Recall Bulletin

PRODUCT SAFETY RECALL

SUBJECT: Replace Ignition Key

MODELS: 2005-2010 Chevrolet Cobalt 2006-2011 Chevrolet HHR 2006-2010 Pontiac Solstice 2005-2006 Pontiac Pursuit (Canada Only) 2007-2010 Pontiac G5 2003-2007 Saturn Ion 2007-2010 Saturn Sky

Replacement Key Modification

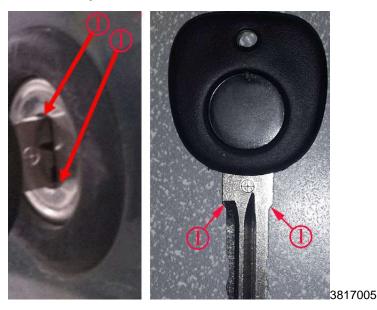
For the Saturn Ion only, if the replacement key profile is wider near the key head than the original equipment manufacturer (OEM) key, it may only work in the ignition lock cylinder and not in the doors or trunk. The replacement key may require modification BEFORE it can be used to open a vehicle door or trunk. Perform the Key Modification procedure in this bulletin if the replacement key will not open the doors or trunk of the vehicle.

1. Using a file, remove the extra width of key near the over molded head as shown in blue (1) in the photograph above. Removing this material makes the width of the key 8.3mm (same as the OEM key) rather than 10mm. This will allow the key to enter fully into the door and trunk lock cylinders.

Note: Without the modification, the key stops on the shoulder and will not fully enter the key lock cylinder. Refer to the photograph.

- 2. Verify key function in the ignition cylinder as well as all door and trunk lock cylinders prior to delivery to the customer.
- 3. Assemble the new key(s), the key fob(s) and the $\frac{1}{2}$ " key ring together.
